REMARKS

Amendment to the Drawings:

FIG 1

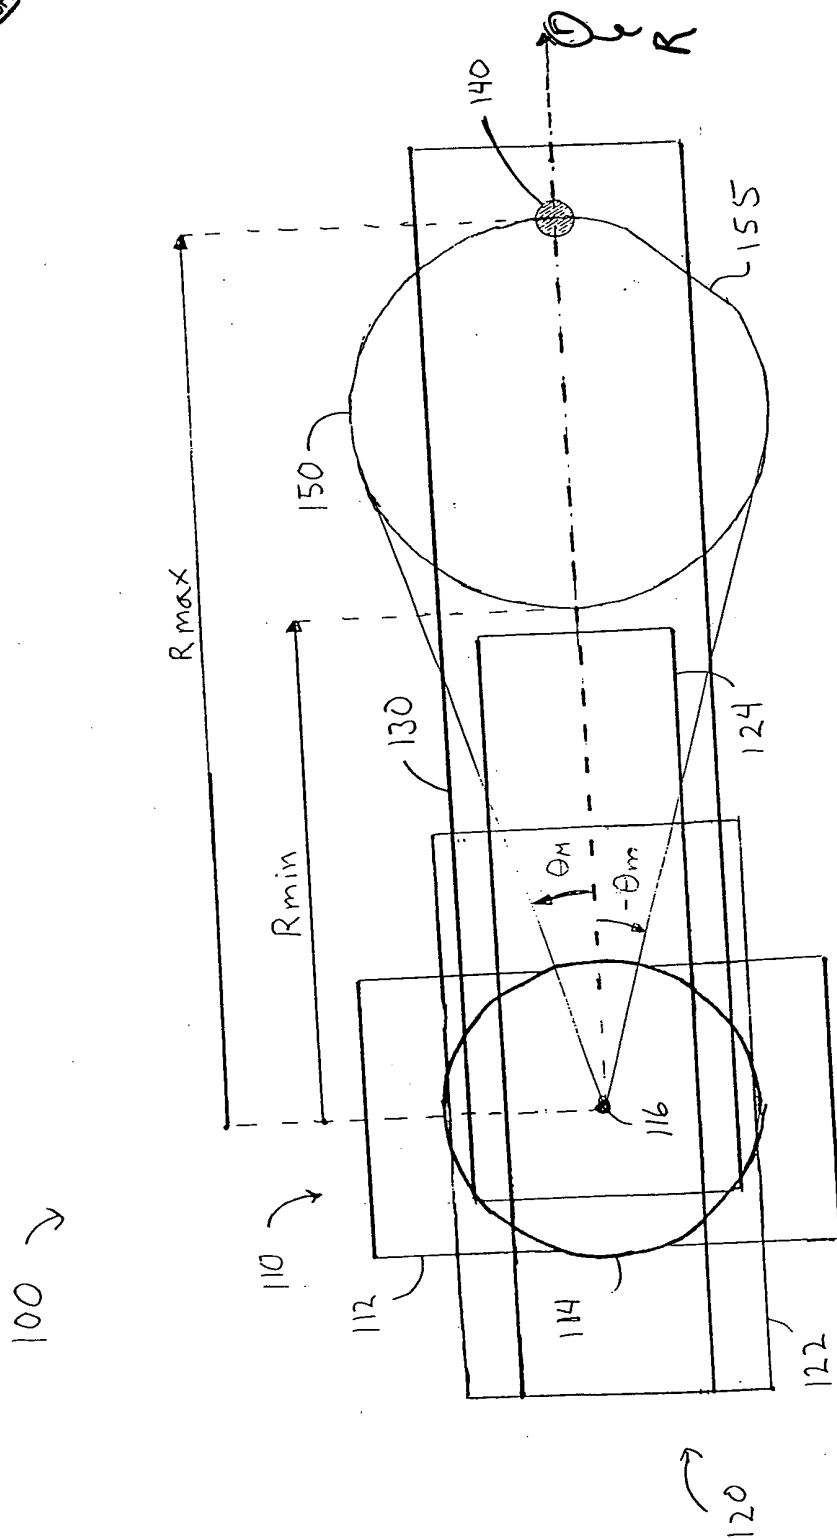
The Examiner object to the drawings stating that Fig. 1 includes r and θ_m which are not mentioned in the description. Fig. 1 has been amended to change the " r " in Fig. 1 to " R " as is disclosed in the text. Moreover, Applicants point out that θ_m is mentioned in the text at page 4, line 18. Figs. 3 and 4 have been amended to change "Rotory Stage" to "Rotary Stage". Replacement sheets for all the figures and annotated sheets showing the changes are attached hereto.

The attached sheets of drawings include changes to Figs. 1, 3 and 4. Replacement sheets for all figures and annotated sheets showing the changes made are attached hereto.
